Report Of The Architectural Commission Meeting - May 20, 2013

MEMORANDUM

TO: Village President and Village Board
FROM: James M. Hogue, Village Planner
DATE: May 22, 2013,
RE: Board & Commissions Report for 5/28/13

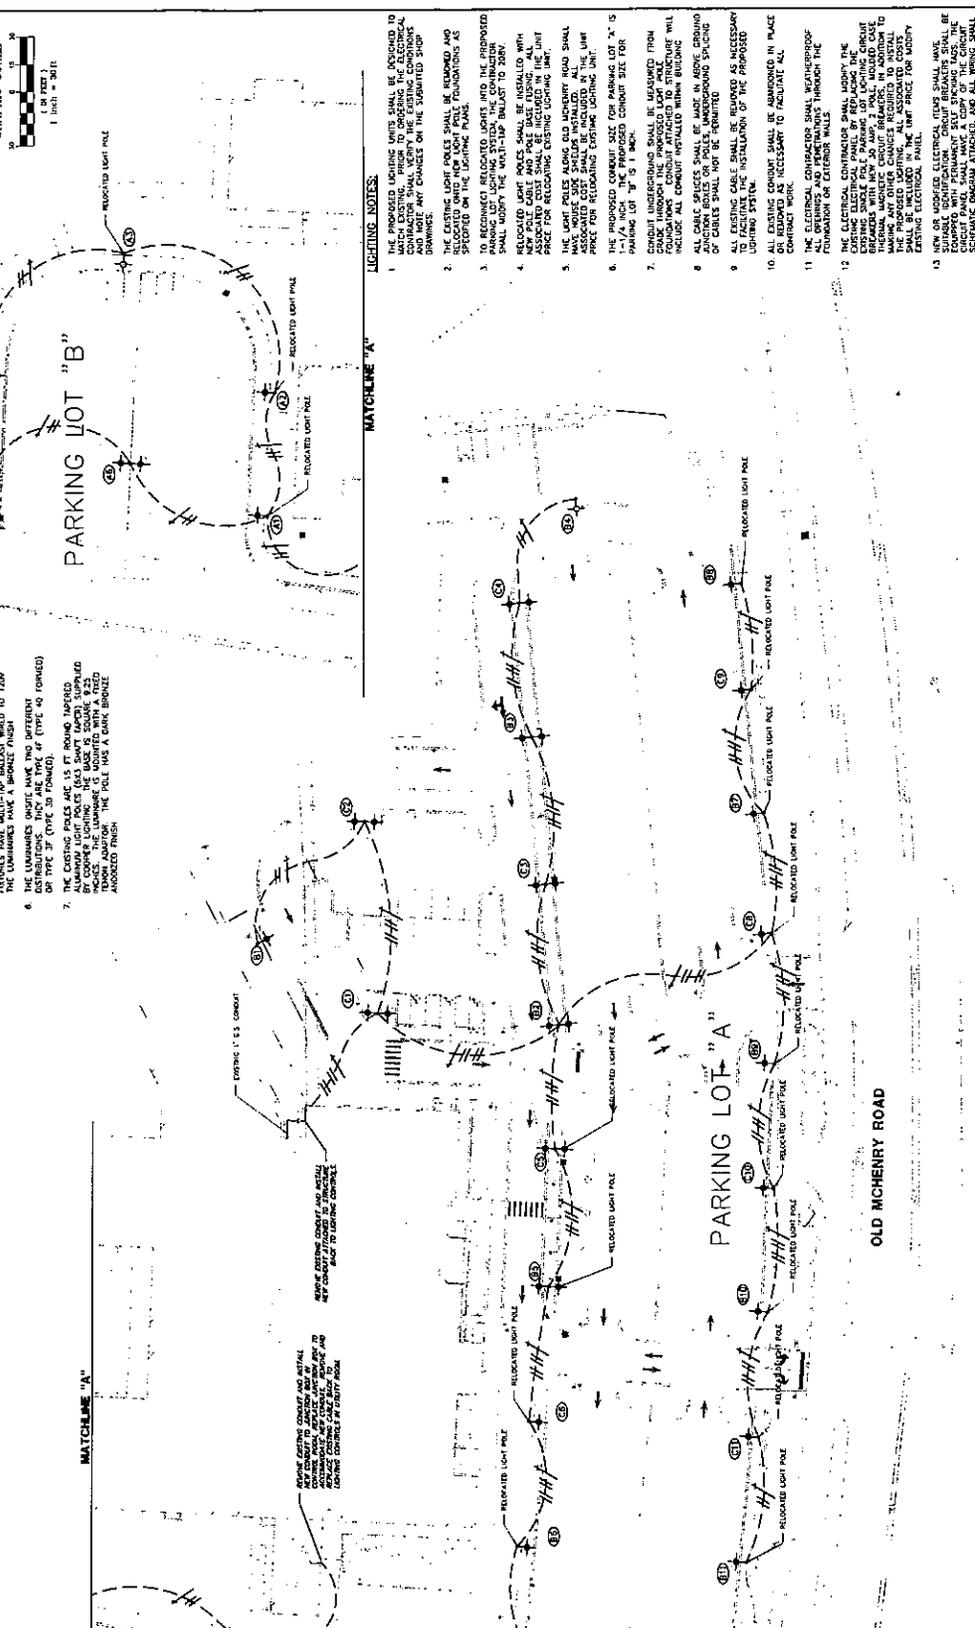
Parking Lot "A" would contain 22 light poles with 30 fixtures. Parking Lot "B" would contain 6 light poles with 7 fixtures (See attached sheet E-1). Double fixtures are proposed for the interior of the areas of the lot nearer to the school building. New poles will be 15 feet tall and will be "Cooper Lighting – round tapered pole" with both a double and single arm arrangements. Fixtures will be "Cooper Lighting – Lumark Tribute Series". These fixtures are "dark sky" compliant. Parking lot lighting will be timer controlled. Lamps will include a metal halide light source with wattage proposed at 250 watts (120 volts). Fixtures and poles will be bronze in color.

The AC questioned if LED lights were considered and if maintenance of the metal halide light source was an issue. The petitioner responded that LED was not considered and metal halide was chosen as it performed well and was consistent with the previously approved and existing lighting. Maintenance of the metal halide lights was not an issue and replacement of bulbs was not often required. The school district hopes to start construction in June.

A motion was made and seconded to approve the lighting plan, fixtures and 250 watt metal halide light source per the plans submitted by Gewalt Hamilton and dated 4.4.13. On a voice vote all aye.

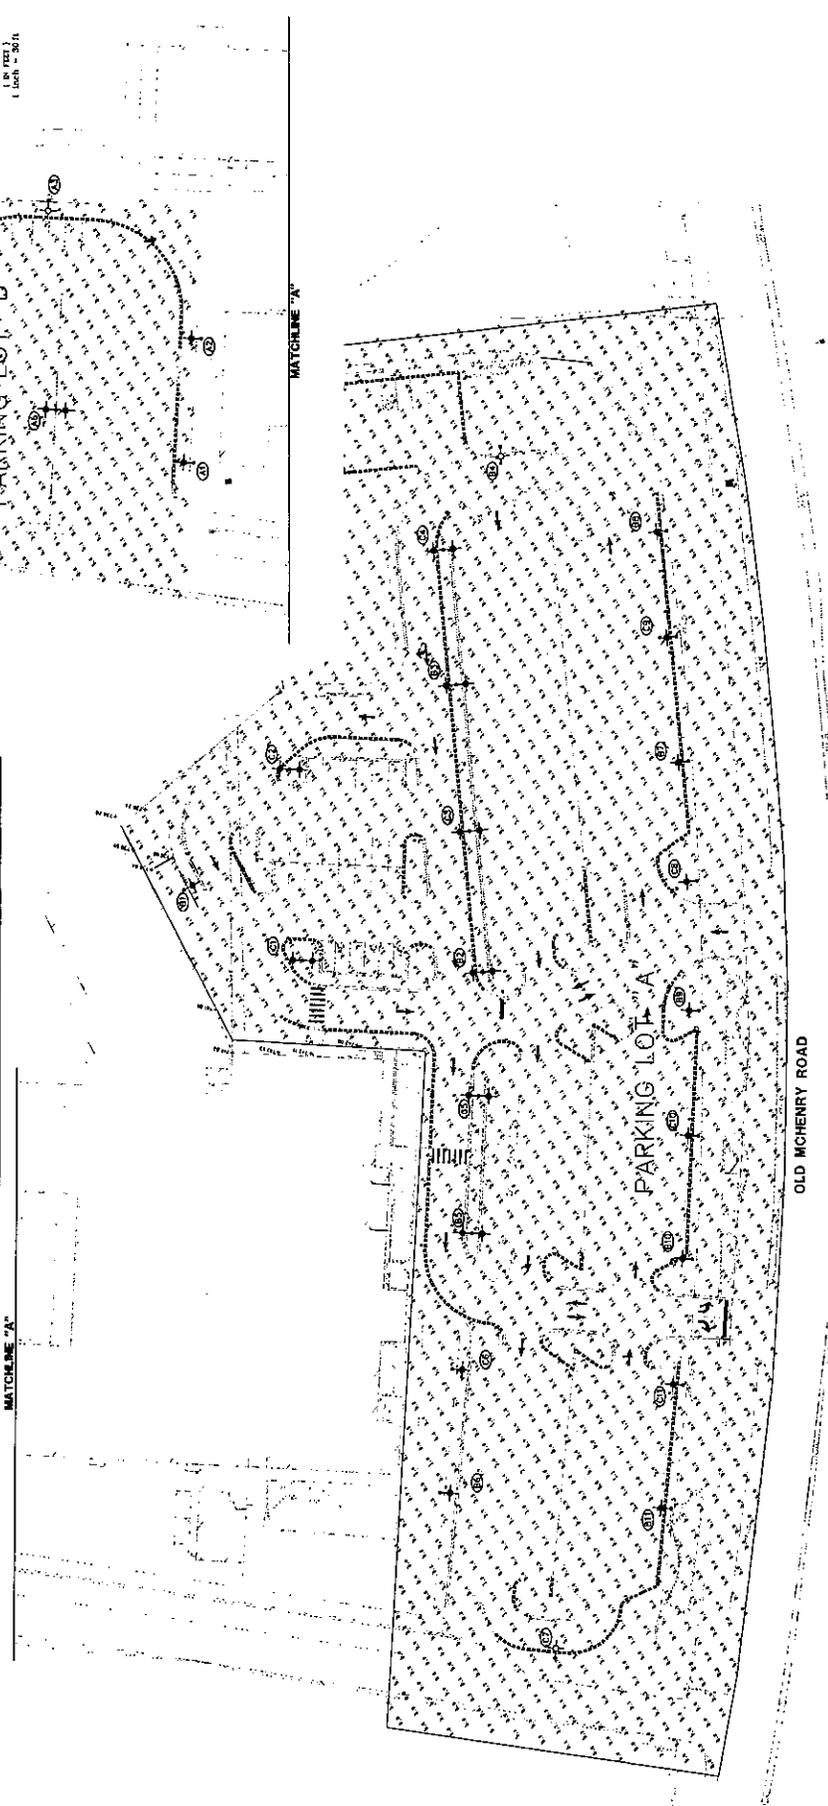
Photometrics as submitted indicate that there will be no "leakage" of lighting off-site (Sheet attached sheet E2).

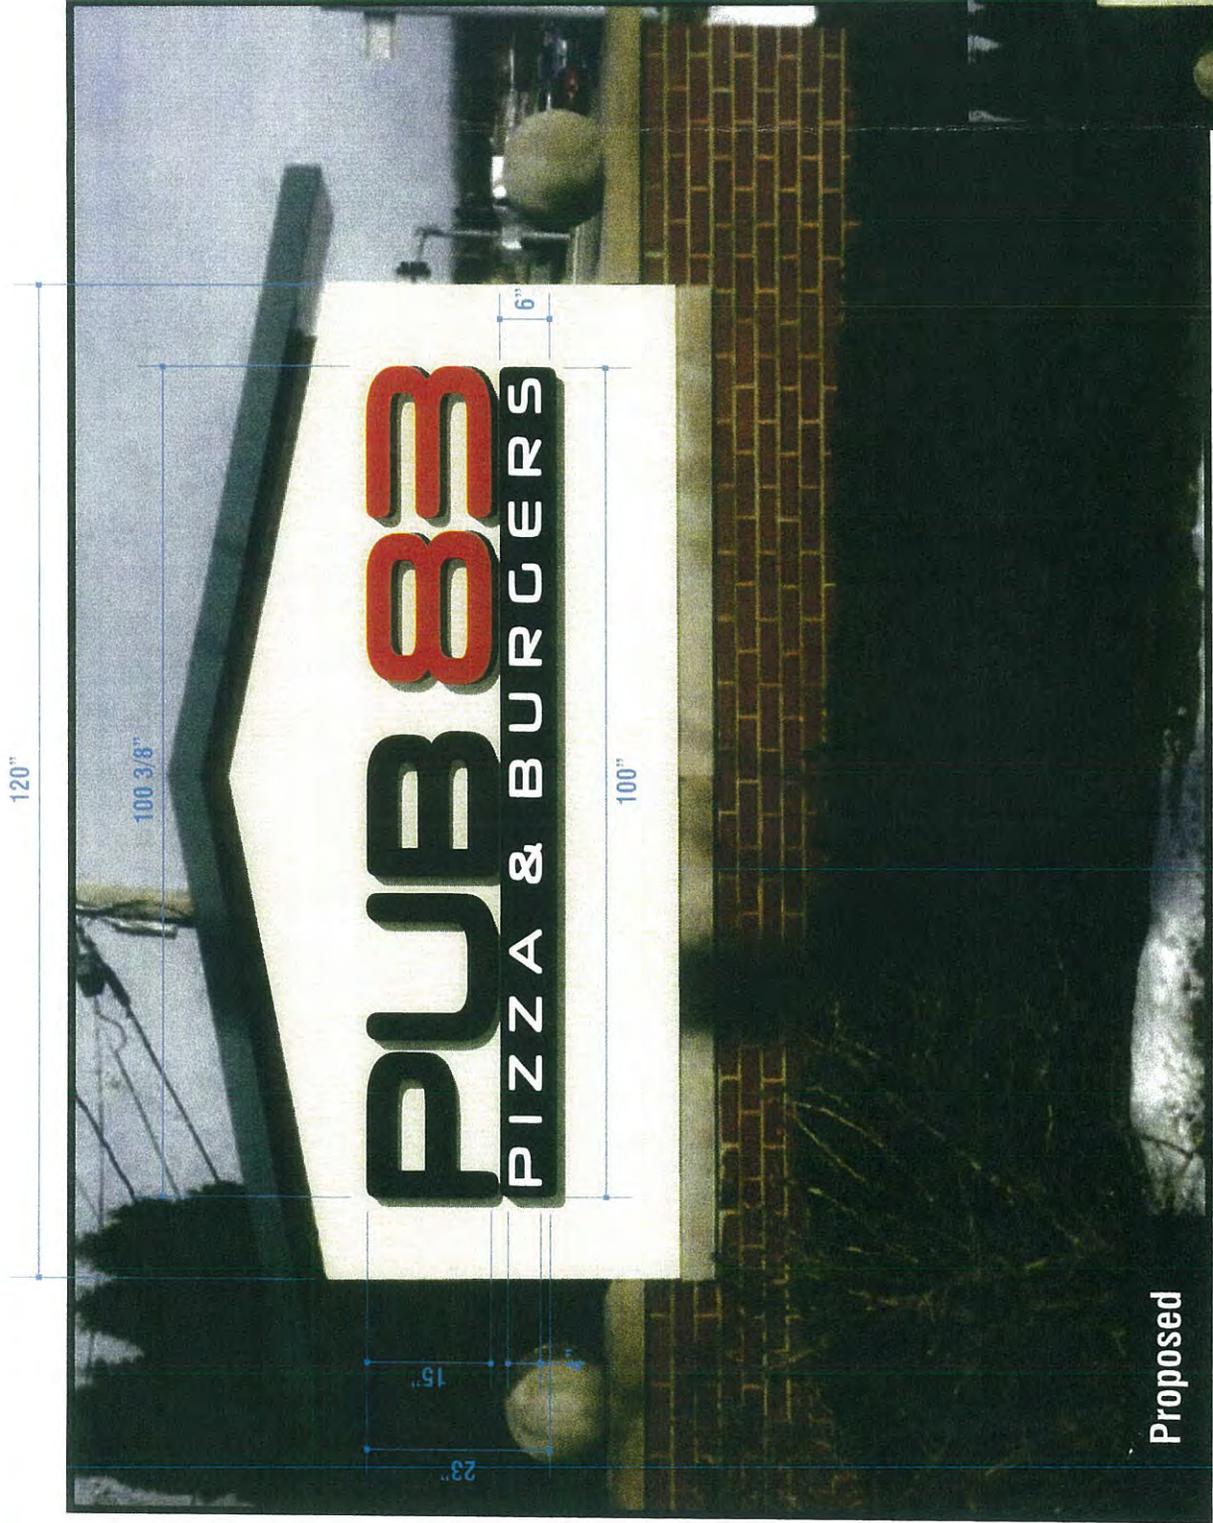
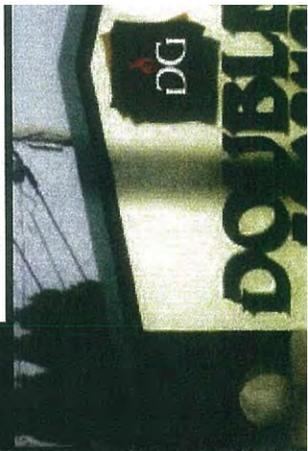
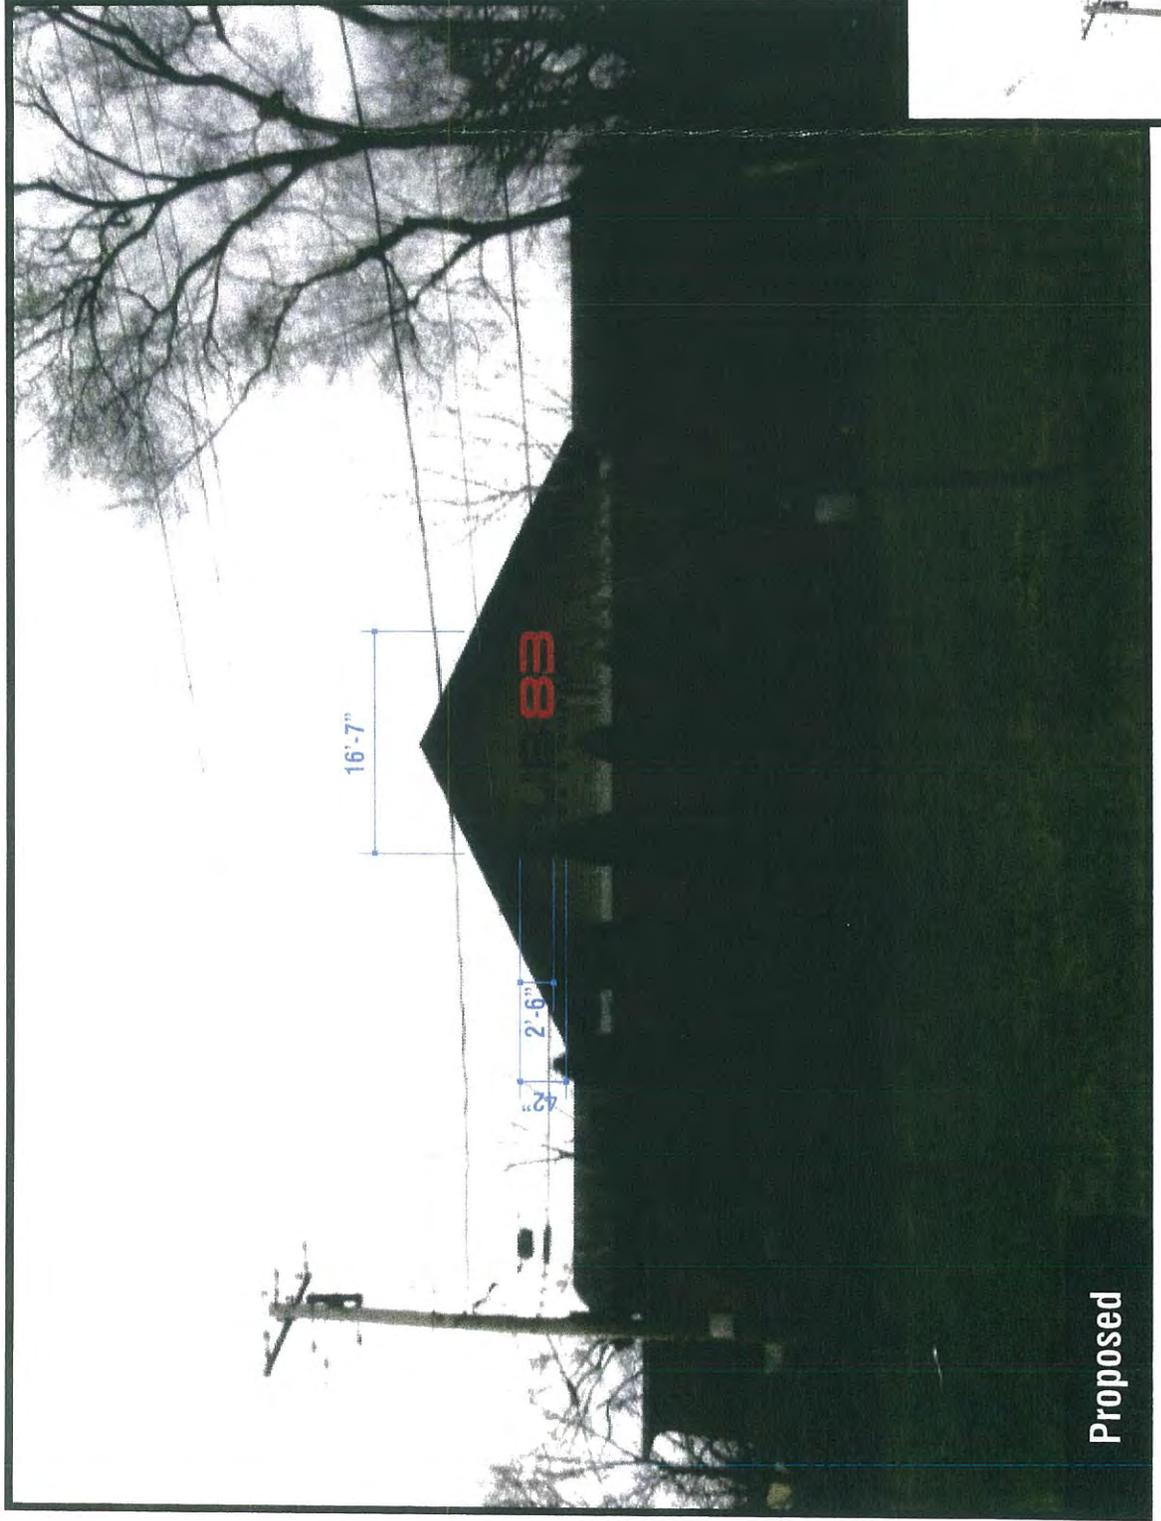
- Signage – Petitioner submitted revised sign details which, among other things, indicate a proposed name change for the restaurant from “Double G’s” to “Pub 83”. Sign color and style remain the same as does the general location of the wall sign on the building. The existing ground sign will remain the same except for the sign face which will be replaced. The second ground sign will remain adjacent to the new entrance on Gilmer Road. The area of the wall sign proposed on the north elevation of the building measures 3.5’ x 16.5’ or approximately 58 square feet of signage. This signage will be constructed of white and red channel letters (polycarbonate faces) w/ black returns and trim caps. Red & white LED illumination is proposed. The ground signs will have an area of 8.3’ x 1.9 feet or 15.77 square feet of sign area. This does not include the background or monument upon which the sign will be placed. The signage will be constructed in the same manner as the wall sign with regard to colors, materials and illumination.

1. Two ground signs, double faced and substantially identical shall be allowed; one as existing with replacement sign faces, another to be located adjacent to the new entrance on Gilmer Road per the submittal to the AC by Kieffer & Co., Inc and dated 4.25.13.
2. One wall sign, to be located on the north façade of the restaurant building shall be allowed per the plan submitted by Kieffer & Co., Inc and dated 4.25.13 shall be allowed subject to the sign being centered on the north façade of the building.
